Planning Commission Issues and Vote Report

Meeting Date: January 13, 2020

Petition: **P.Z. 09-2019 18301 & 18357 Chesterfield Airport Rd. (Nasrallah Global RE Services):**
A request for a zoning map amendment from a “M3” Planned Industrial District to a “PC” Planned Commercial District for a 15.9-acre area of land comprised of two (2) parcels at 18301 and 18357 Chesterfield Airport Road, located northwest of the intersection of Chesterfield Airport Road and Spirit of St. Louis Boulevard. (17V430035 and 17W620301).

RE: 18357 & 18301 Chesterfield Airport Road
Change of Zoning Submittal
Cochran Project # M18-7572

PRELIMINARY PLAN

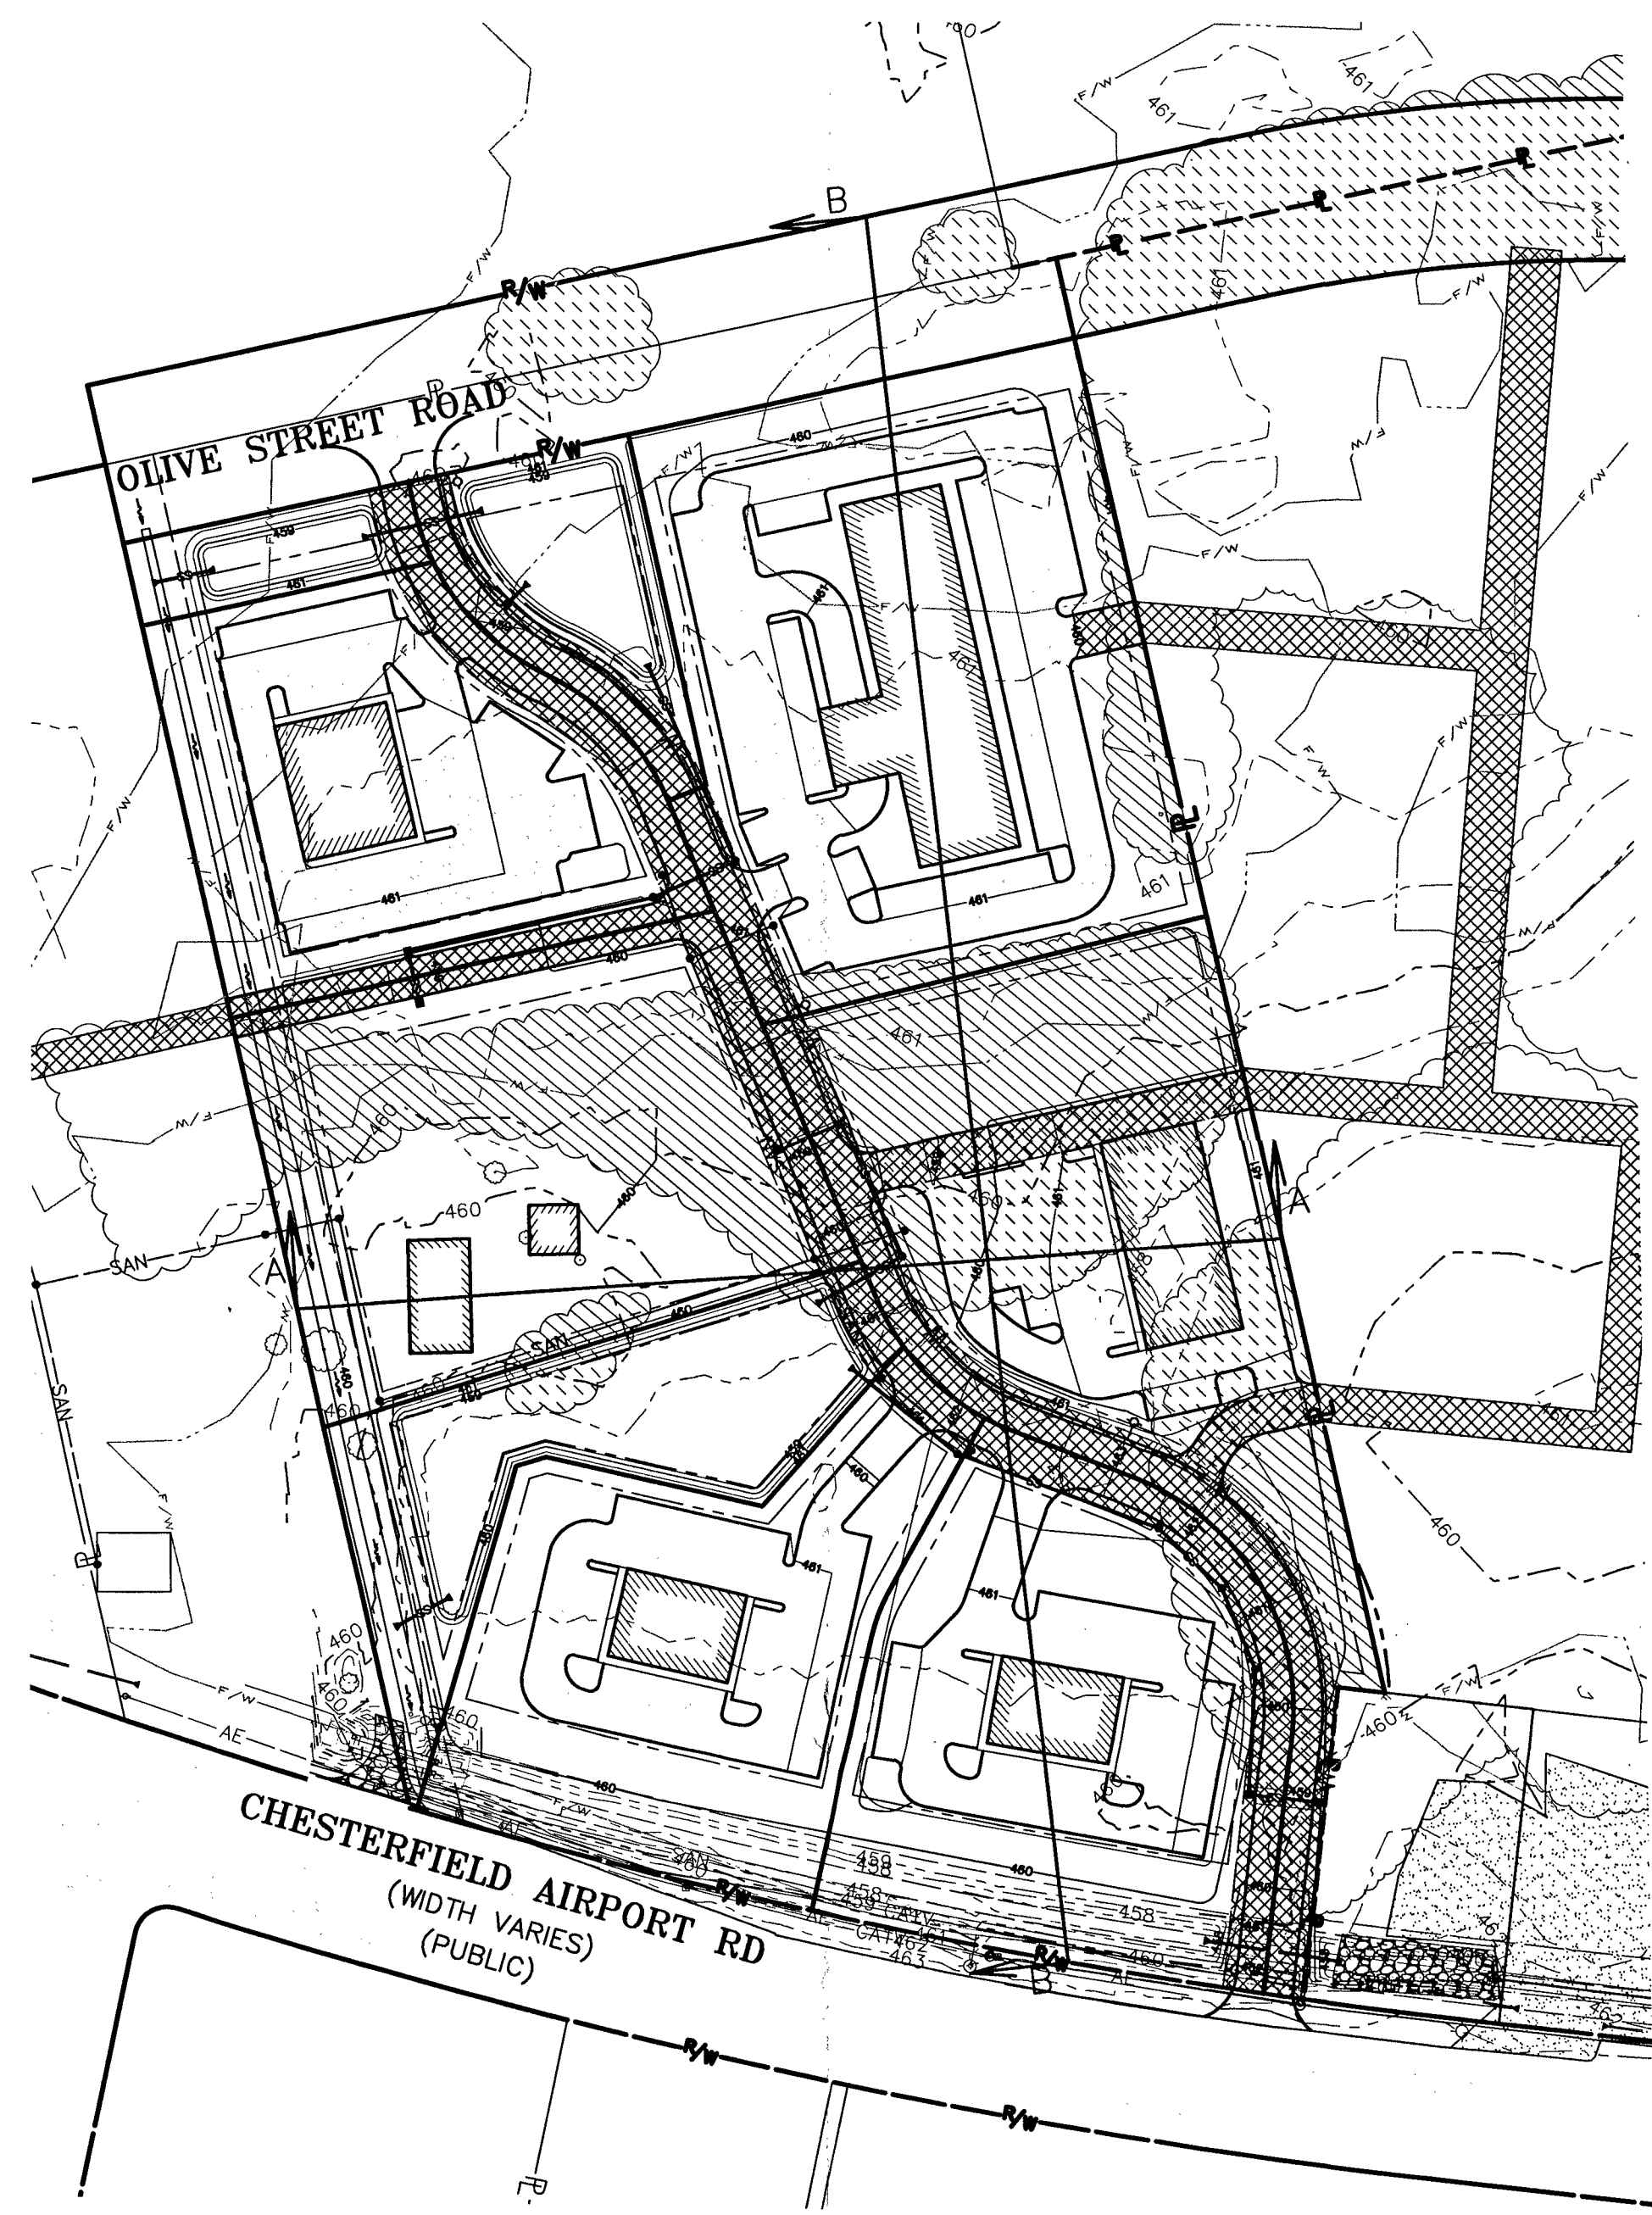
- a. Concern was raised over the amount of proposed access connections into the development specifically onto arterial roadways (Chesterfield Airport Road and Olive Street Road). Address how this issue is to be alleviated or elaborate on the necessity of these access points.

- b. Identify on the plan how the western cross access will connect to the private road, utilizing the Concept Plan for that adjacent development.
Cross access to the adjacent property to the West is shown via ingress/egress easement which lines up with an existing cross access easement on the Western property shown on the plat bk 349, pg. 57. The adjacent property to the West is private property and is not owned by the project property owner. Any future improvements to the adjacent property, including building and connecting roadways to connect to the project property, are at the discretion of the owner. Per the previously mentioned approved plan of the adjacent property to the West we have shown cross access on the project property to accommodate future access to the private road. Any future access to the private road to the West will be considered secondary to any access connections to Chesterfield Airport Road and Olive Street Road and is not intended to carry a major percentage of the traffic flow to or from the project site but rather act as an internal connection point between commercial developments.

2. Historic Structures: Concerns were raised about the future plans of the historic barn on the site. Elaborate on the intended plans for this structure.
The currently submitted plans show the historic barn to remain. Our client feels the barn is an asset to the development and would like it to remain. The particular lot which contains the barn has already had interest shown due to the barn's presence. There have been many ideas pitched for the proposed use of the barn, including but not limited to, wine bar, micro-brewery, and general commercial. The final proposed use shall be up to the client developing the lot so long as it meets the City's approved uses for the property.

3. Parking: Chesterfield Valley Design Requirements state that parking for developments shall be located primarily to the side or rear of each building façade facing Chesterfield Airport Road, North Outer 40 and Interstate 64 so as to not be seen from the road. Revise the plan to reflect this requirement for all lots for which this issue applies.
The currently shown layout of parking on each lot was intended to show the appropriate amount of parking could be placed on each lot. The parking and building layout shall be site and client specific, which means the layout shown on the plans will almost certainly be different than the proposed layout for each lot at the time of developmental submittals.

The access point proposed to attach to Chesterfield Airport Road shall conform to all St. Louis County Department of Transportation requirements. Access management requirements of the City of Chesterfield including spacing and sizing shall also be met. Access to Chesterfield Airport Road shall be required for this property because there are currently no streets or roads to the West, East, or North for the project property to gain access. Both of the adjacent properties to the West and East are private property not owned by the project properties owner, but do have cross access ingress/egress easements for connection once the properties develop. The proposed New Olive Road to the North, even with the proposed improvements shown on the current submitted plan, does not grant access to any currently constructed roadway. Beyond the portions of Olive Street Road shown on the currently submitted plans to the East will be a connection to Spirit of St. Louis Blvd. and to the West a connection to the portion of New Olive Road the ice rink built, but neither connections have been made, nor are they planned at this point and both are contained on private property not owned by the project property owner. Chesterfield Airport Road is the only currently viable access point to provide access to or from the project property and is currently the main arterial providing access for commercial and industrial properties in this Western portion of Chesterfield. Beyond the portions shown on these plans

and the portions built by the ice rink Olive Street Road has no capability to carry traffic due to its lack of connections to arterial roadways like Chesterfield Airport Road and Spirit of St. Louis Blvd. Until Olive Street Road is constructed and connected to Spirit of St. Louis Blvd. and Chesterfield Airport Road itself has no ability to ease traffic flow volumes from Chesterfield Airport Road. Initial traffic flow to and from the project property will be done through the connection at Chesterfield Airport Road and is shown to connect to the future Olive Street Road in the hopes of dividing the traffic flows entering and leaving the project property through the use of two connection points to arterials instead of one. Breaking up the traffic flows in this way should ease the amount of entering and leaving traffic at the Chesterfield Airport Road access location.

Parking for all lots in this future development shall meet all applicable City of Chesterfield City Code, including parking requirements.
